SUBJECT: NuScale Power, LLC Response to NRC Request for Additional Information No. 136 (eRAI No. 8933) on the NuScale Design Certification Application

eRAI No.: 8933

NRC Question No.: 03.07.02-17

Figure 1-15. Cracked RXB Y Acceleration Transfer Function Amplitude Comparison at Node 27692, Crane Rail Slab between Grid Lines RX-4 and RX-5 at El. 145'-6", for Soil Type 7.

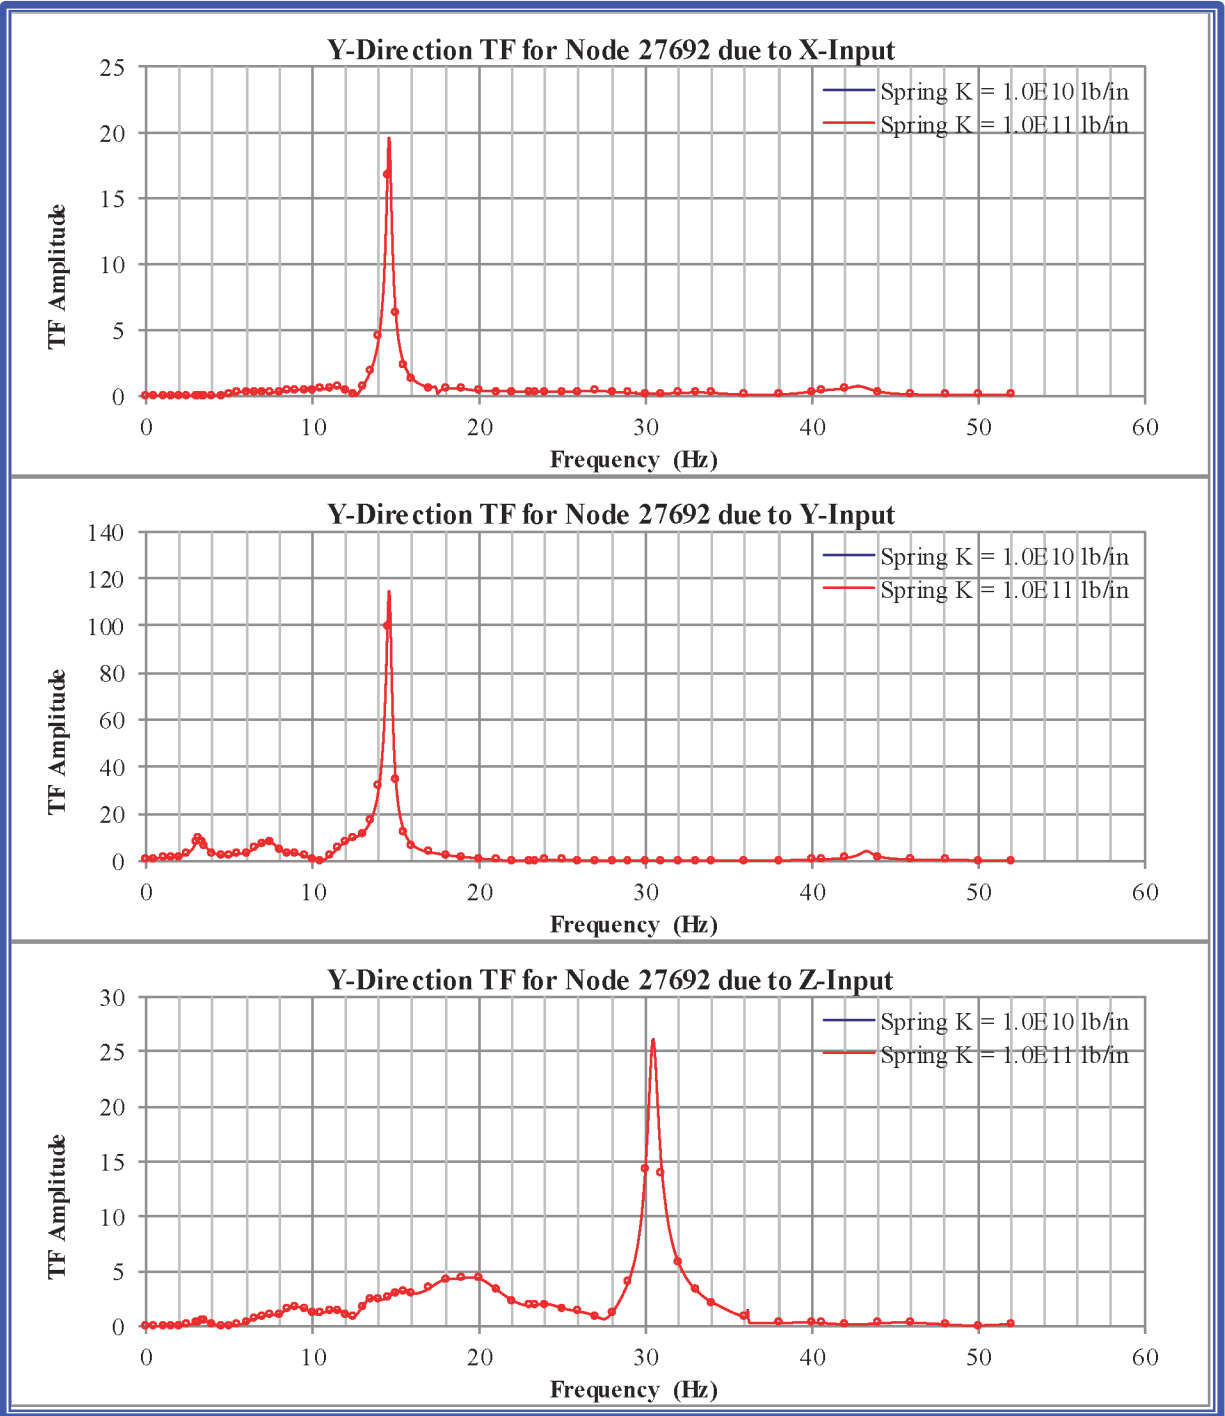
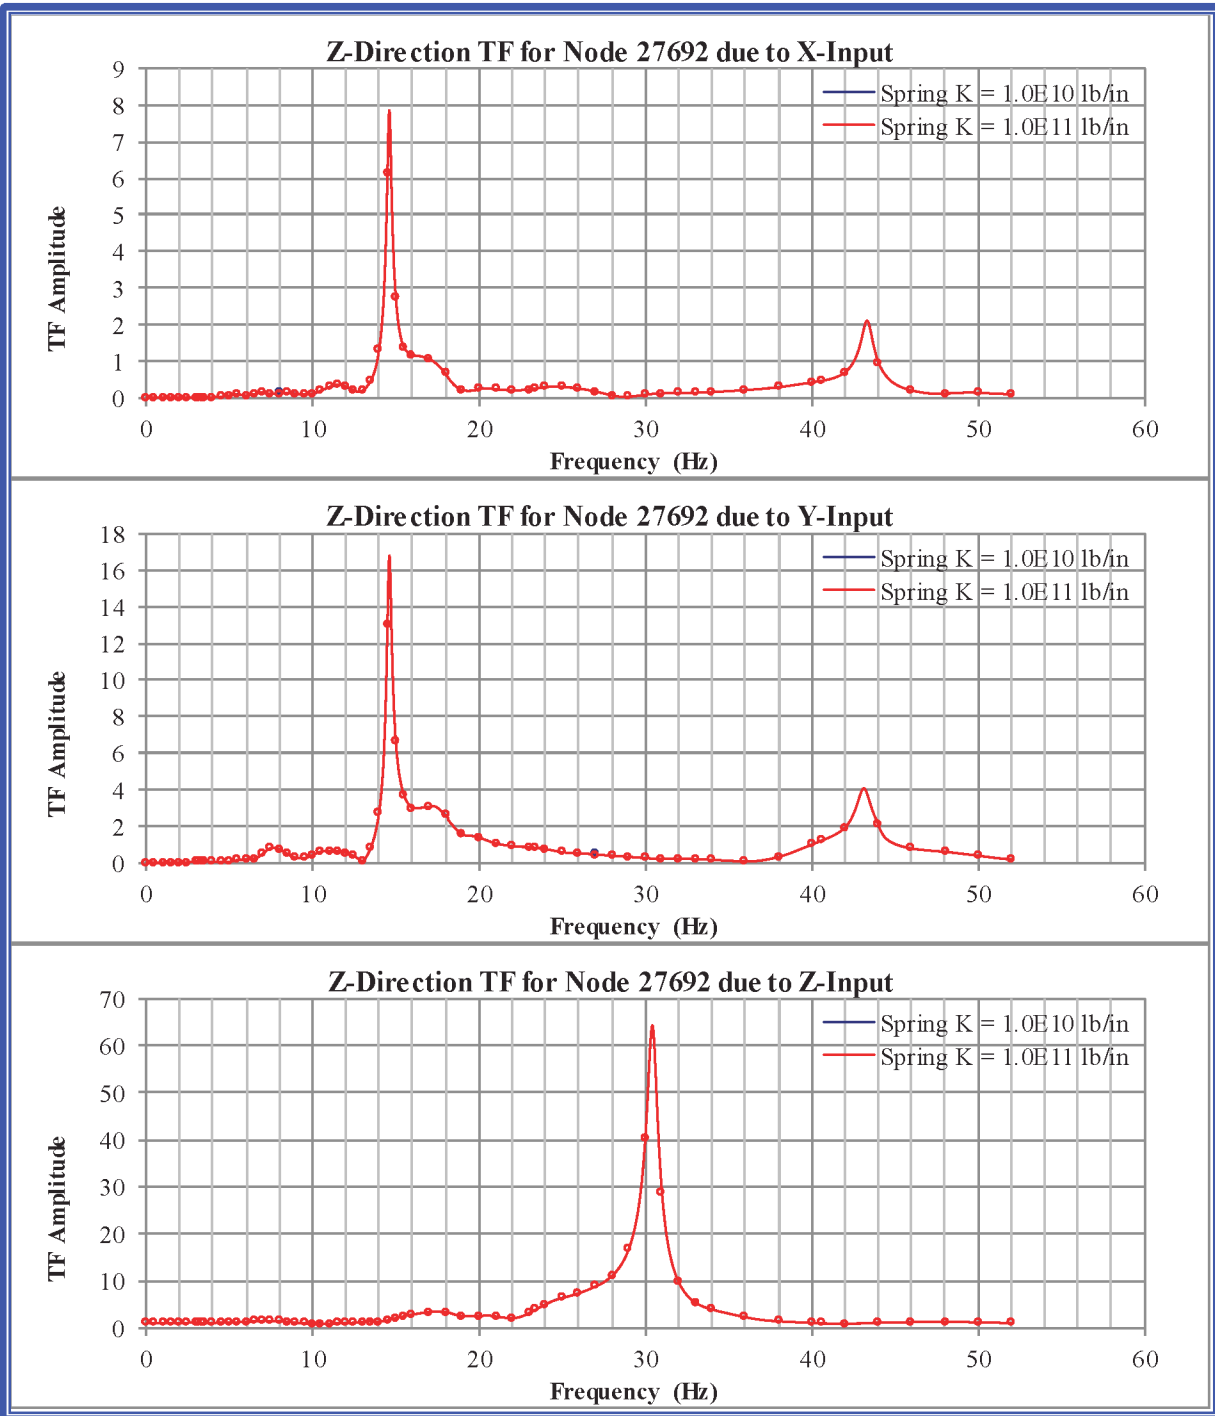
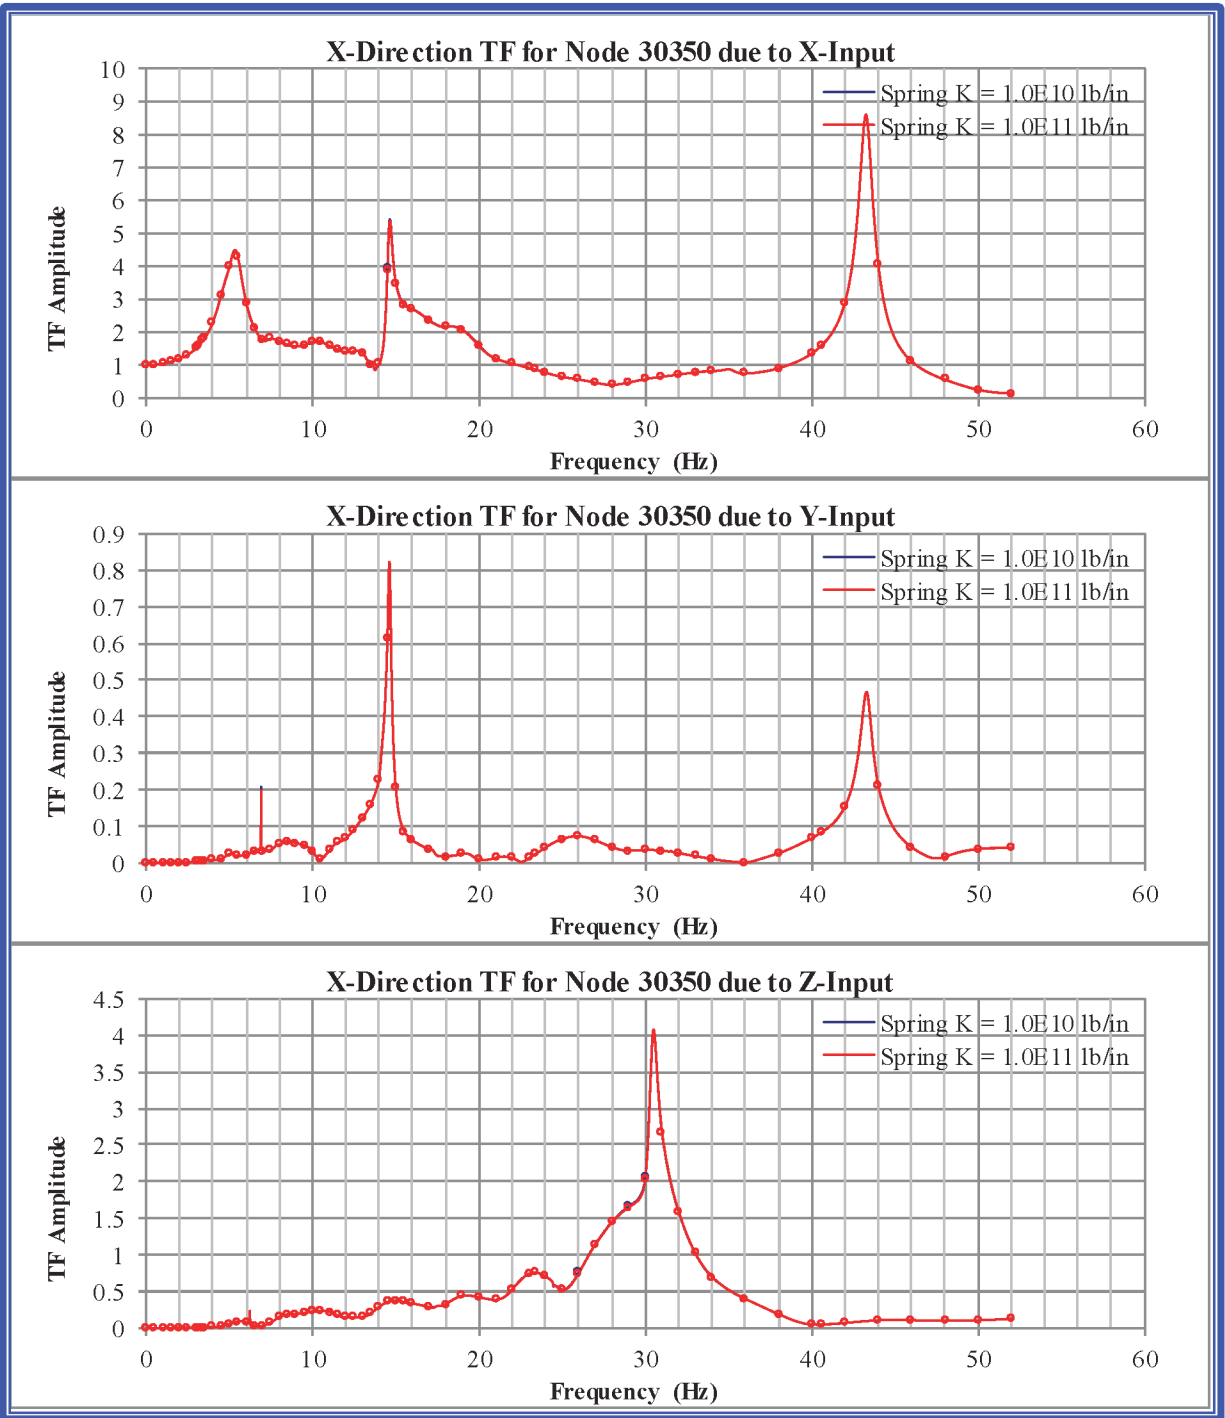
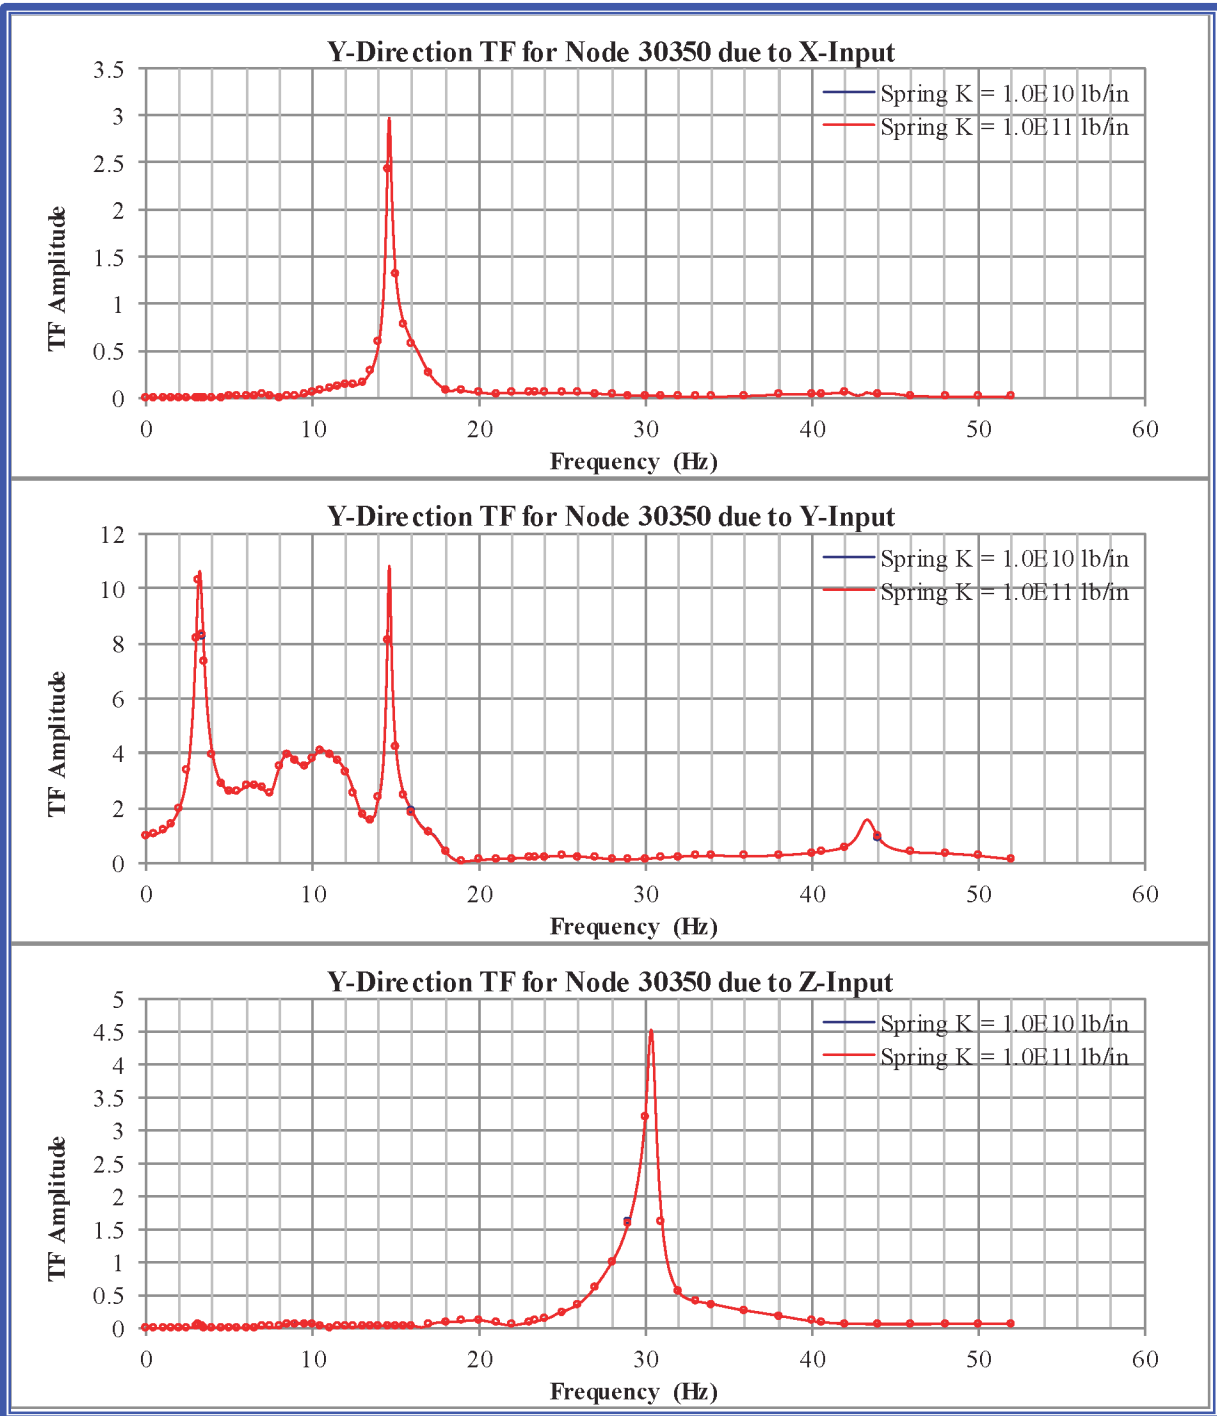
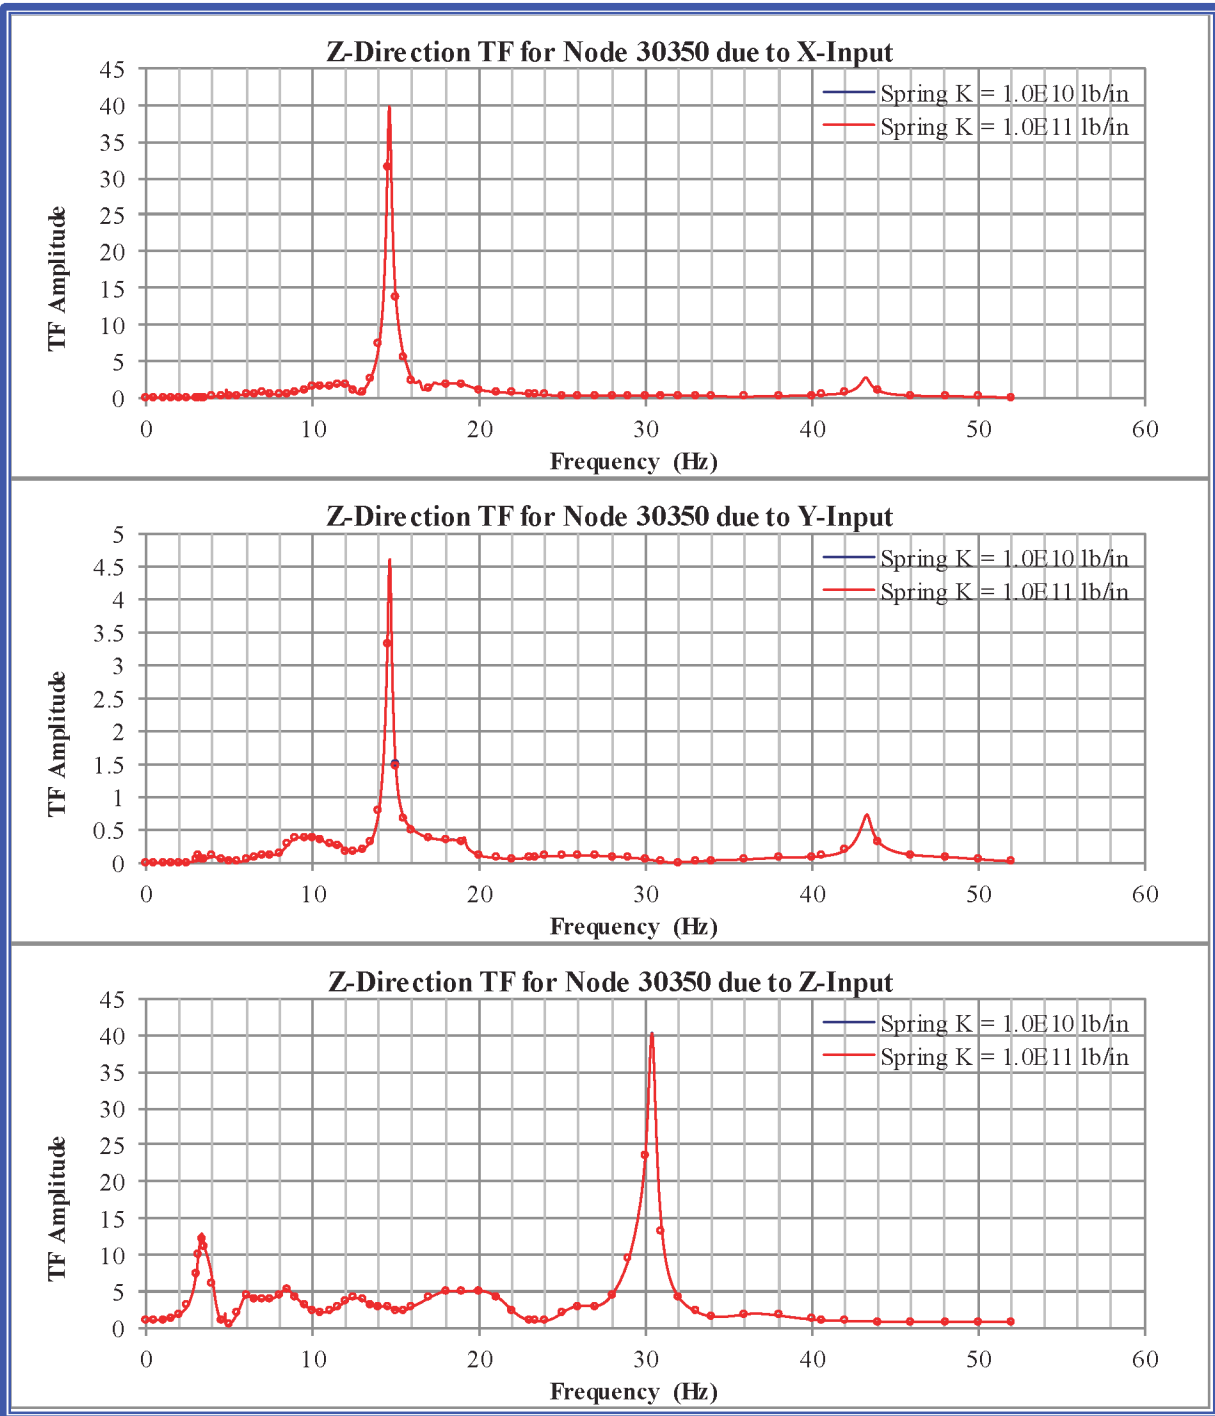
- b. On Page 3.7-25 of the FSAR, in the sixth paragraph, the applicant states, “The rigid springs have a zero length and have a stiffness value large enough to simulate rigid connection. The large stiffness used is arbitrarily chosen to be ten billion lbs per inch, or 1010 lbs/inch, in the three global directions.” For the spring to be modeled as a rigid spring, the value of its spring constant should be sufficiently larger than the stiffness of the structural element (basemat) to which it is attached. The applicant is requested to confirm the adequacy of the number (1010 lbs/inch) chosen for the spring constant by comparing it to the stiffness of the adjacent basemat element or through an appropriate sensitivity run using a number at least an order of magnitude different.

The locations of the nodes are shown in Figure 1-1 through Figure 1-4. The cracked concrete model with 7% concrete damping was used to generate these results. The TF comparisons are shown in Figure 1-5 through Figure 1-19. There are no discernible differences in the transfer functions between spring $K = 10^{10}$ lb/in and spring $K = 10^{11}$ lb/in.
